SUBJECT: Transmittal of Westinghouse Responses to US NRC Requests for Additional Information on the AP1000 Application for Design Certification

AP1000 DESIGN CERTIFICATION REVIEW

RAI Number: 440.173 (Response Revision 2)

Figure 440.173R2 -5

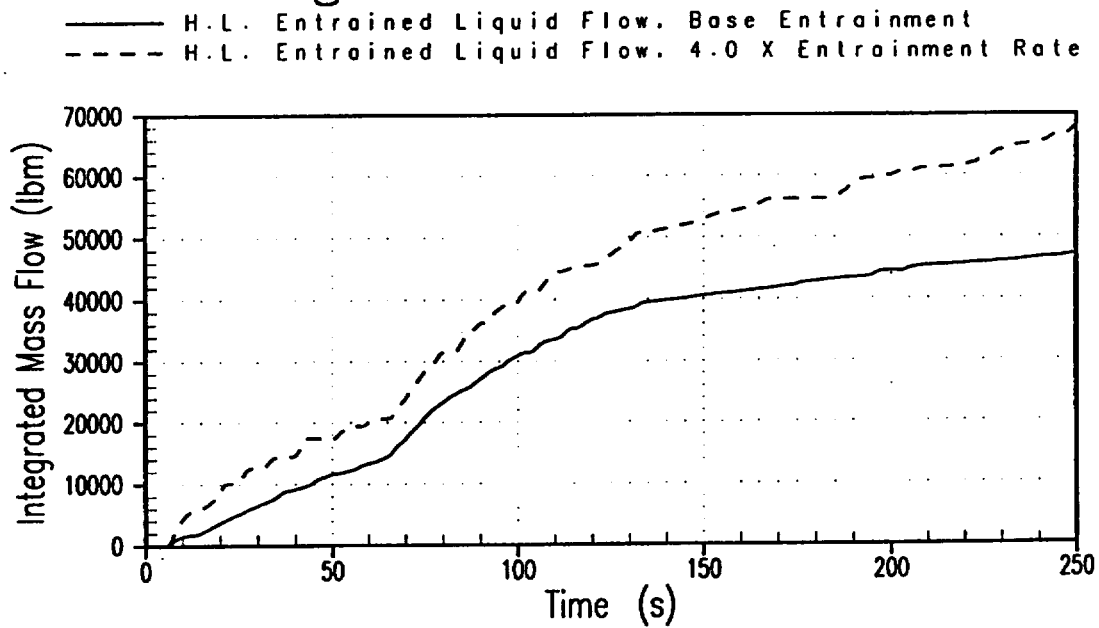
Is the sensitivity to entrainment small because the net effect is negated by additional de-entrainment? If not, please provide justification that the de-entrainment fractions observed in these sensitivities is adequate. In addition, please provide information on flow from the core to the upper plenum. The flow has considerable oscillation, and conditions in the upper plenum may depend more on the process of continuous liquid flow at the top of Channel 10 rather than on the upper plenum region calculations. Include a figure of the collapsed liquid level in the core, in your response.

The impact of the calculated upper plenum entrainment rate upon these two cases is small because up until 125 seconds, the total liquid mass flow rates out the hot legs are approximately equal. The integrated flows of the entrained fields from the two cases are shown in Figure 440.173R2-5. Figure 440.173R2-6 shows that up to 70 seconds the higher entrained flow into the hot legs in the [4 x rate] case results in increased back flow of continuous liquid to the upper plenum. Up until 125 seconds, the higher entrained flow in the [4 x rate] case is offset by the greater continuous liquid field flow into the hot legs in the base case (Figure 440.173R2-6), so the total liquid flow rates into the hot legs are approximately the same. The upper plenum masses are also about the same at 125 seconds. The liquid present in the lower two cells of upper plenum channel 15 is primarily continuous liquid (Figure 440.173R2-7) in the base case, whereas in the [4 x rate] case the liquid content of the lower two cells of channel 15 is mostly entrained droplets (Figure 440.173R2-8). The same condition exists in upper plenum Channel 47 at 125 seconds (Figures 440.173R2-9 and -10). Over the next 15 seconds, the same behaviors occur in both cases in these channels; continuous liquid fractions remain constant or even increase a bit, while the entrained droplet mass decreases markedly. The continuous liquid flow exiting Channel 15 is about zero in both cases (Figure 440.173-14 and Figure 440.173-14e) but the entrained liquid flow continues (Figure 440.173-15 and Figure 440.173-15e). Therefore, as a consequence of which liquid field is present, the base case retains most of its upper plenum liquid over the 125-140 second time span, but the [4 x rate] case upper plenum liquid inventory is reduced somewhat. Flow through gaps 21 and 24 into the hot legs is
